Service Bulletin

American Honda Motor Co., Inc.

2006 GL1800 Airbag CB Radio Squeal

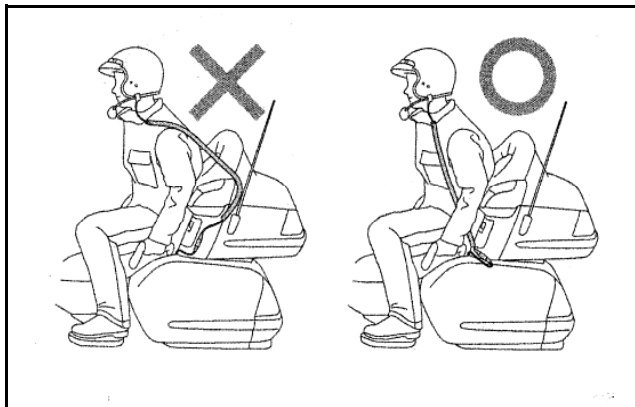
Some 2006 GL1800 Airbag models equipped with the optional accessory CB radio may experience a squealing noise when transmitting.

To remedy this problem, a ferrite core harness kit is now available for installation.

- The kit includes both a rider and a passenger harness; it's necessary to install both harnesses to eliminate the squealing noise.
- Passengers must route the headset cord as shown. If routed otherwise, it will be too close to the motorcycle's antenna, which can create an interference.

Install a ferrite harness core kit according to the installation instructions that are packaged with the kit.

IDENTIFICATION

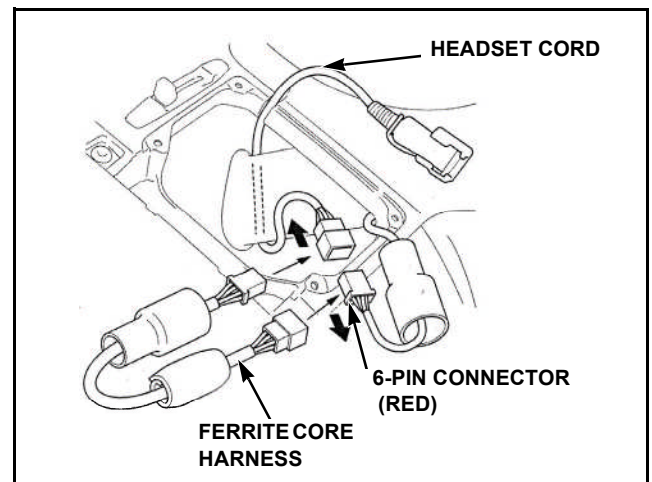
Subharness installation can be confirmed by removing the left-side fairing pocket, and checking to see if the harness is already installed.
